**LFPCNAT2023-001**

**Product Change Notification for Littelfuse**

MOSFET DISCRETE, IGBT DISCRETE over 650V in TO-247 package adding new manufacturing location

## 1. POD – Package Outline Dimension

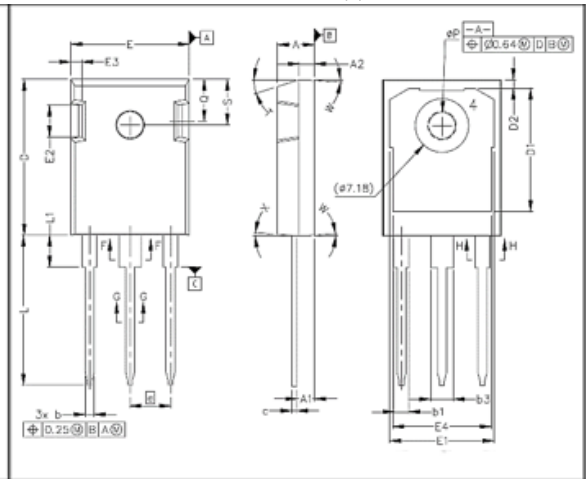
Items	Littelfuse		New Supplier		Remark
	Min	Max	Min	Max	
A	4.70	5.30	4.83	5.21	
A1	2.21	2.59	2.29	2.54	
A2	1.50	2.49	1.91	2.16	
D	20.79	21.45	20.80	21.10	
E	15.48	16.24	15.75	16.13	
E2	4.31	5.48	3.68	5.10	Body Notch Area
e	5.46BSC		5.44BSC		
L	19.80	20.30	19.81	20.32	Lead Length
L1	-	4.49	4.10	4.40	
ΦP	3.55	3.65	3.51	3.65	
Q	5.38	6.19	5.49	6.00	
S	6.14BSC		6.04	6.30	
b	0.99	1.40	1.07	1.33	
b2	1.65	2.39	1.91	2.41	
b4	2.59	3.43	2.87	3.38	
c	0.38	0.89	0.55	0.68	
D1	13.07	-	16.25	17.65	
D2	0.51	1.35	0.95	1.25	
E1	13.45	-	12.38	13.43	
ΦP1	-	7.39	7.18BSC

Conclusion: There is variance between POD in existing and new supplier in line E2 and L. The variance although is not significant in application on customer side.

Datasheets will be updated.

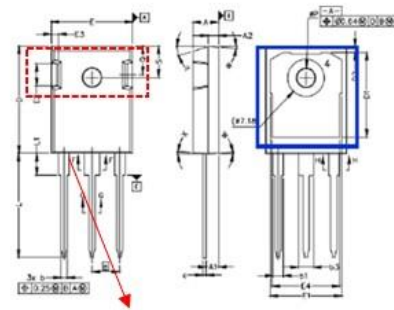
New Supplier has different dimension and shape on body notch area compared to Littelfuse Original POD

Supplier 1

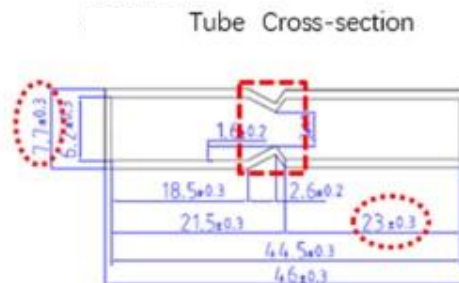
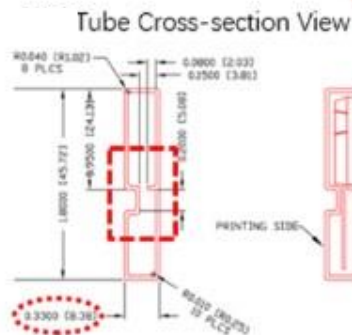
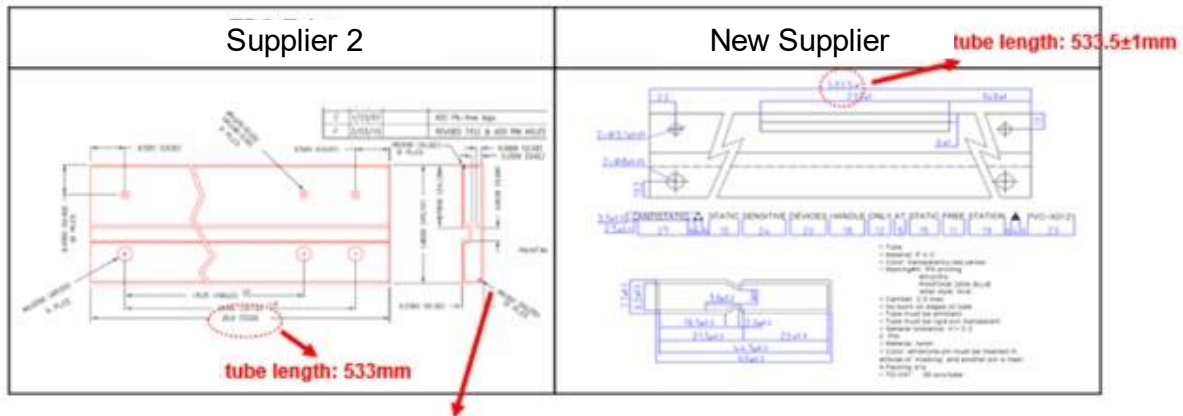
**Note:** (1). No additional change in Label layout for Logo/Part No/Lot No/Qty/Date Code between Supplier 1 and New Supplier. The only change is for assembly location from Korea to China.

Supplier 2

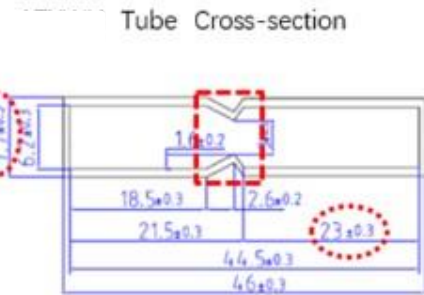
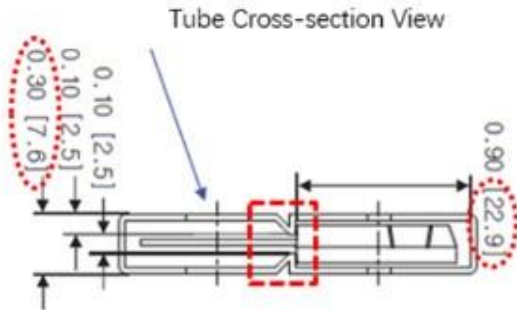
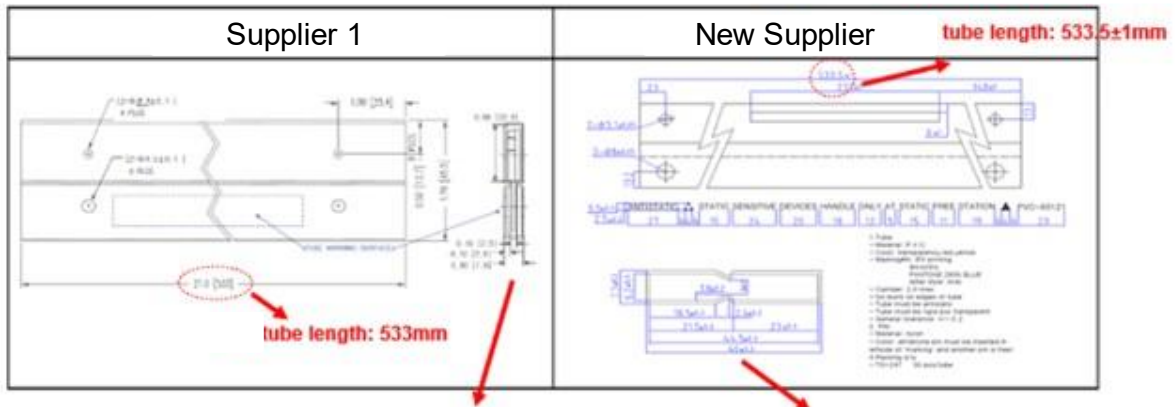
**Note:** (2). No additional change in Label layout for Logo/Part No/Lot No/Qty/Date Code between Supplier 2 and New Supplier. However, there is a change on the logo location and assembly location from Philippines to China.

**Note:** (3). For New Supplier labeling, there will be super lot# printed in a separate label and this label will only be attached to inner box as below.
